Amendments to the Drawings:

DOCKET NO.: HITACHI-0012

Serial No.: 09/650,506

Response to Office Action of October 27, 2003

FIG. 1

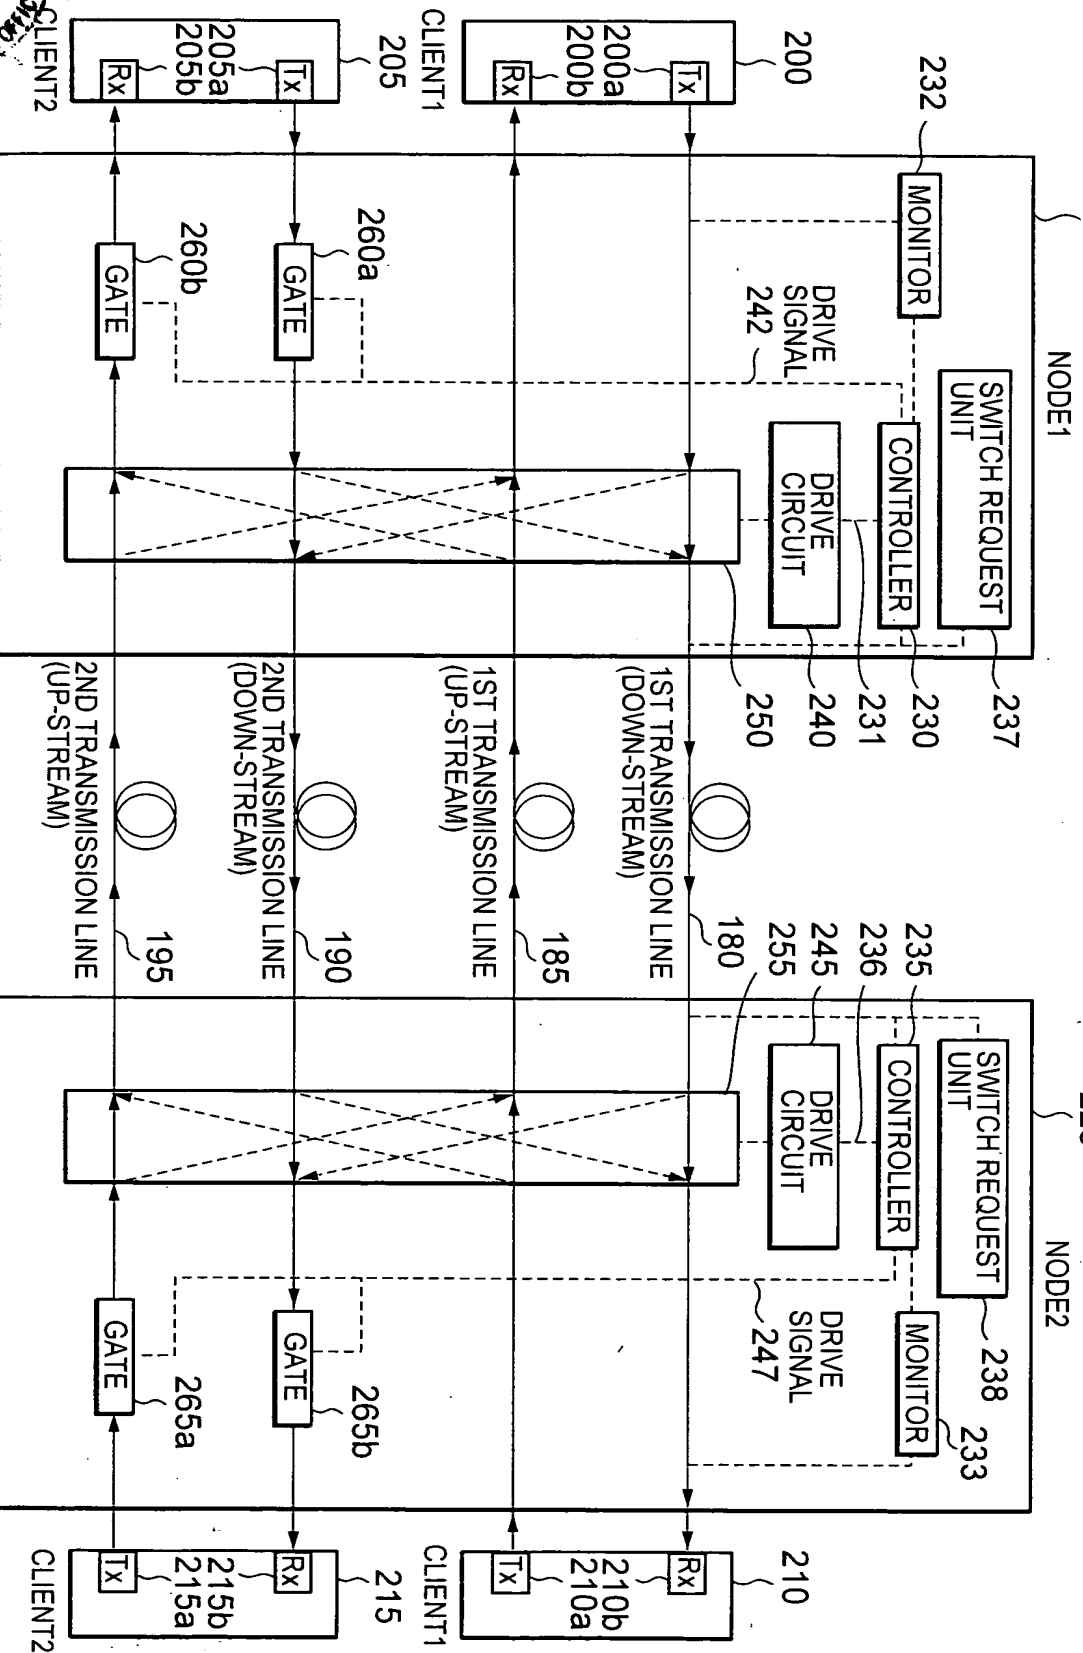
In Fig. 1, in the node 220, please add element 232 --MONITOR-- in the top left hand corner and element 237 --SWITCH REQUEST UNIT-- in the top right hand corner. Also in Fig. 1, in the node 220, please add dotted lines linking element 232 to element 230 and linking element 232 to "1ST TRANSMISSION LINE 180." Please also add dotted lines linking element 237 to "1ST TRANSMISSION LINE 180" and linking element 230 to "1ST TRANSMISSION LINE 180."

Also in Fig. 1, in the node 225, please add element 233 --MONITOR--in the top right hand corner and element 238 --SWITCH REQUEST UNIT-- in the top left hand corner. Also in Fig. 1, in the node 225, please add dotted lines linking element 233 to element 235 and linking element 233 to "1ST TRANSMISSION LINE 180." Please also add dotted lines linking element 238 to "1ST TRANSMISSION LINE 180" and linking element 235 to "1ST TRANSMISSION LINE 180."

FIG. 13 PRIOR ART

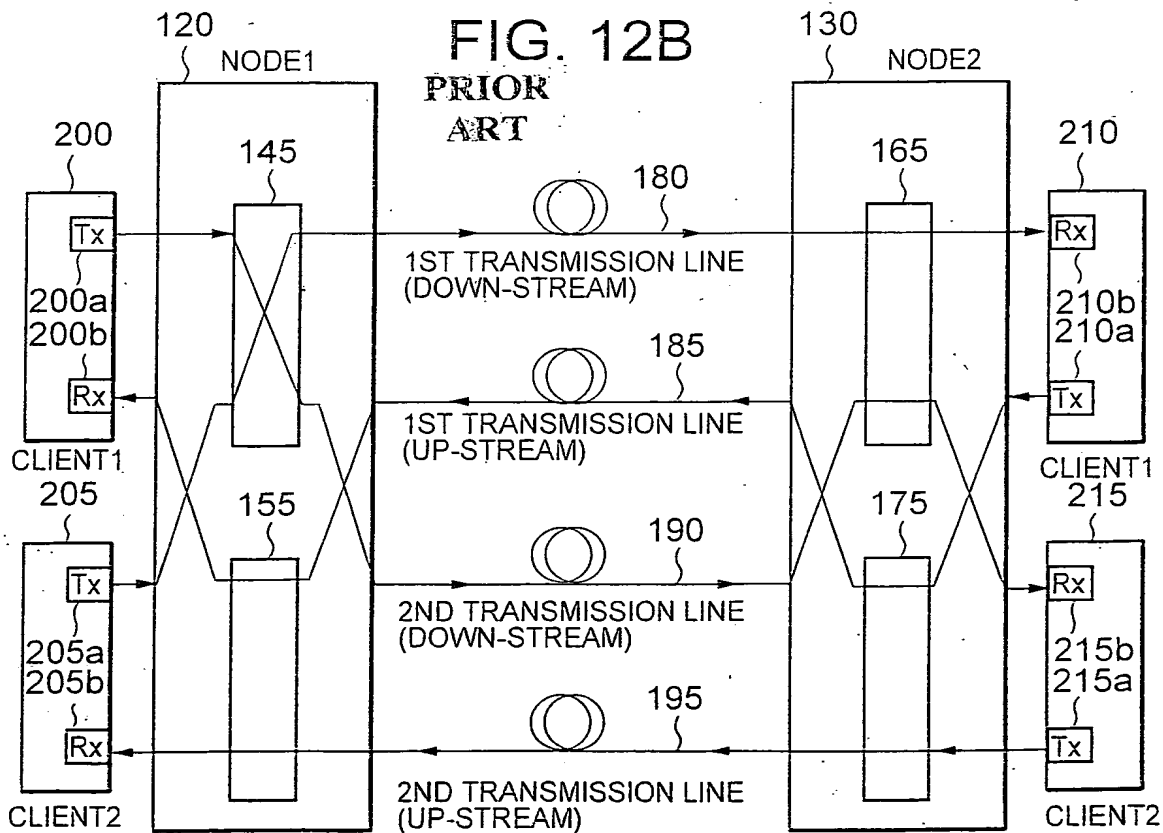
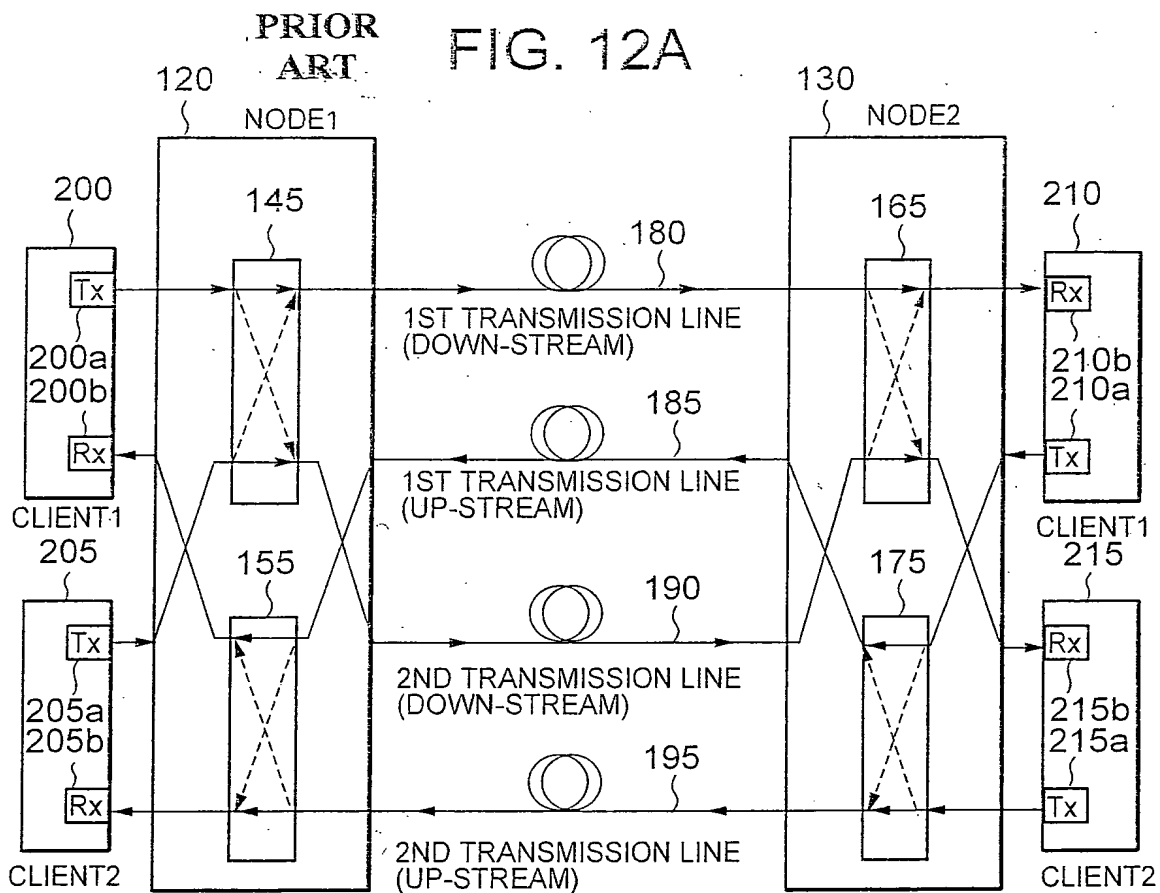
In Figs. 12A, 12B and 13, a "Prior Art" label has been added.
